<b>TO:</b>	Helen Donaldson, Senior Planner	<b>DATE:</b>	7/2/2018
<b>FROM:</b>	Michael Guethle, PE; Ryan Wingard, PE	<b>PROJECT NO.:</b>	13982B
<b>SUBJECT:</b>	St. John St. - 222; MMC Parking Garage (PL-000207-2018)

Wright-Pierce has reviewed the Level III Site Plan Application information provided for the Employee Parking Garage redevelopment proposed at 222 St. John Street. The project will include redeveloping an existing parking lot into a nine-level parking garage with approximately 2,400 parking spaces; redeveloping another existing parking surface to provide a pedestrian access and vehicle access to levels 1-8 of the building; and redeveloping a third parking surface to provide 52 additional spaces of surface parking. Off-site improvements to St. John Street and D Street are also included in the proposed work. The work will reduce the total impervious surface square footage on the property by 14,506 SF.

a. Sheet 17: St John Street and D Street Intersection

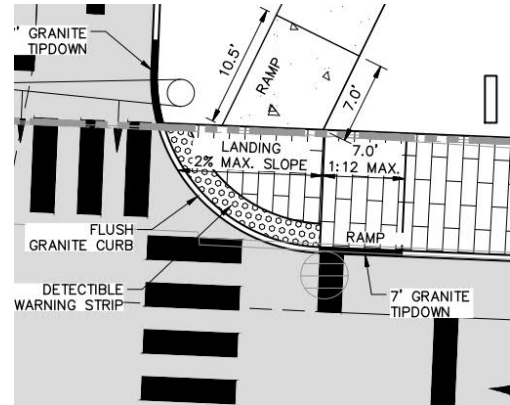
- i. Catch Basin at intersection of D Street and St. John St. is located in a transition ramp next to flat curb (image to right). Applicant shall provide spot grades or detail confirming how this catch basin grate shall be constructed with the adjacent tipdown curbing, and within a bicycle lane.
